PRODUCT CHANGE NOTIFICATION (PCN)

AKSNT/x BLACK
Jumper Connector

CHANGE NOTIFICATION:	PCN 20220303_AKSNTxBLACK
DESCRIPTION OF CHANGES:	CHANGE OF PRODUCT LOCATION CHANGE OF DATA SHEET New Draw.-No. ASS_1004_COrev04
REASON FOR CHANGE:	CHANGE OF PRODUCT LOCATION CHANGE OF PRODUCT DIMENSIONS, TOLERANCES AND/OR PROPERTIES
KEY CHARACTERISTICS OF CHANGE:	Details see page 3
PRODUCTS AFFECTED:	AKSNT/x BLACK
DATE OF CHANGE AND IMPLEMENTATION:	CHANGE: WEEK 10 / YEAR 2022 IMPLEMENTATION: 03.03.2022
RESPONSE:	NO RESPONSE TO THIS NOTIFICATION IS REQUIRED

AKSNT/x BLACK — OLD VERSION

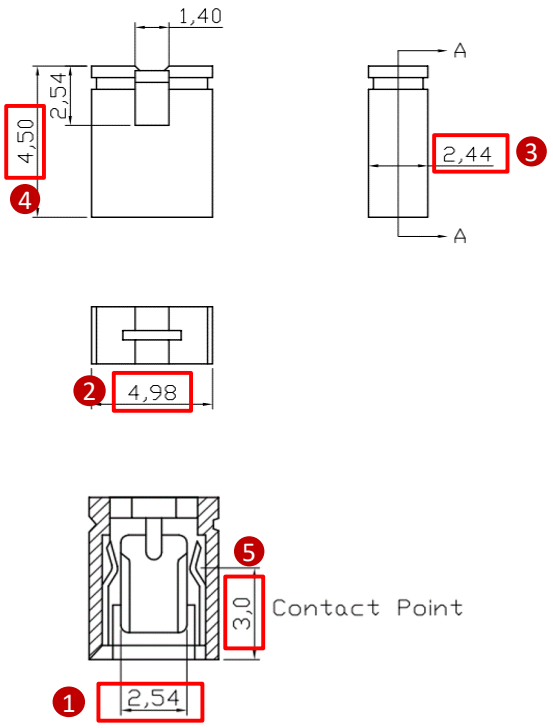
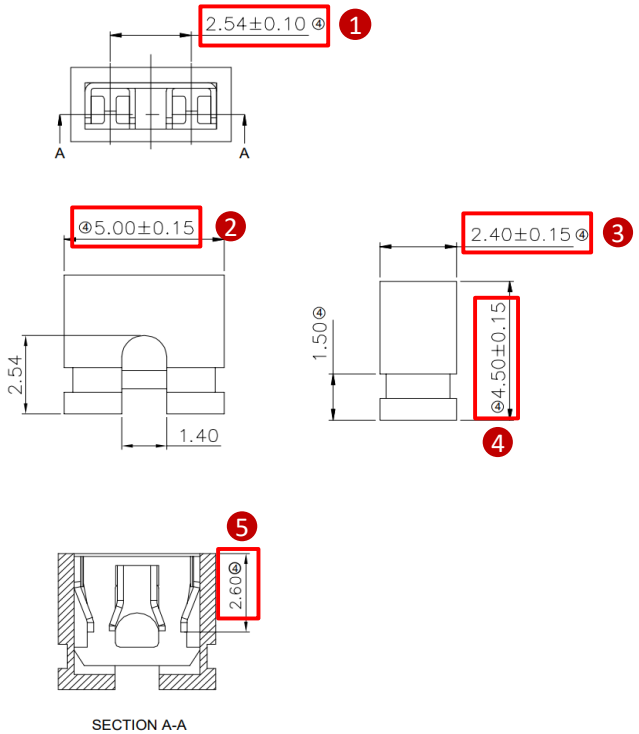
ASSMANN WSW P/N	Drawing Number		ASSMANN WSW P/N	Drawing Number
AKSNT/x BLACK	ASS_1004_CO rev03	↔	AKSNT/x BLACK	ASS_1004_co rev04

1.Insulator: PBT+30% G.F,UL94V-0,Black
④ 2.Contact : Phosphor Bronze,Au or Sn over Ni
3.Current Rating: 3.0AMP
4.Dielectric Withstanding Voltage: 1000V AC/ minute
④ 5.Insulation Resistance: 500MΩ Min.
④ 6.Contact Resistance: 20mΩ Max.
7.Operating Temperature: -40°C ~ +105°C
③ AKSNT/x BLACK
└── Contact Area Plating: ③
G: Gold Flash
Z: Tinned

Drawing-No. ASS 1004 CO rev04

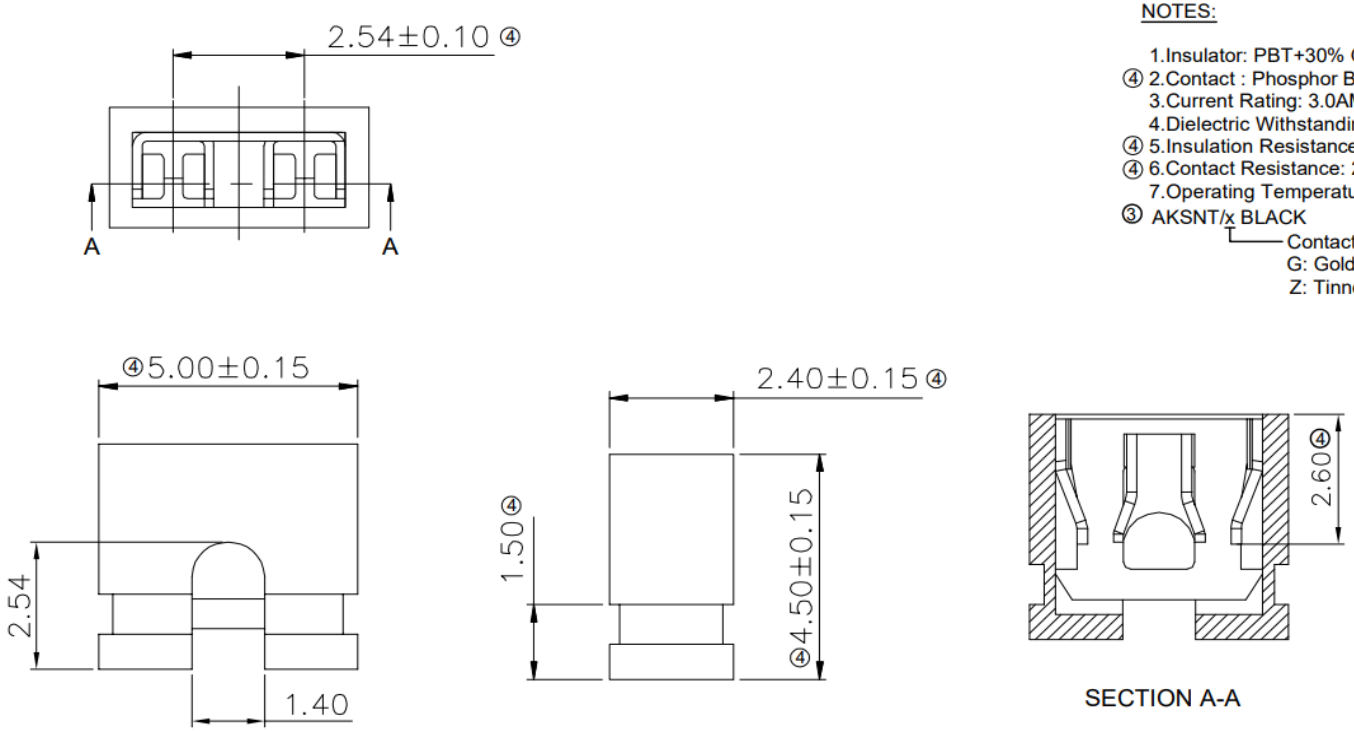
Id.	Modification	Date	Name
④	Update the dimension and tolerance	02.03.2022	Peter
③	Update	07.06.2013	Winnie
②	Update	27.07.2009	Rale
①	Drawn	03.03.2004	Hellwig

1.Insulator: PBT+30% G.F,UL94V-0,Black
④ 2.Contact : Phosphor Bronze,Au or Sn over Ni
3.Current Rating: 3.0AMP
4.Dielectric Withstanding Voltage: 1000V AC/ minute
④ 5.Insulation Resistance: 500MΩ Min.
④ 6.Contact Resistance: 20mΩ Max.
7.Operating Temperature: -40°C ~ +105°C
③ AKSNT/x BLACK
Contact Area Plating: ③
G: Gold Flash
Z: Tinned
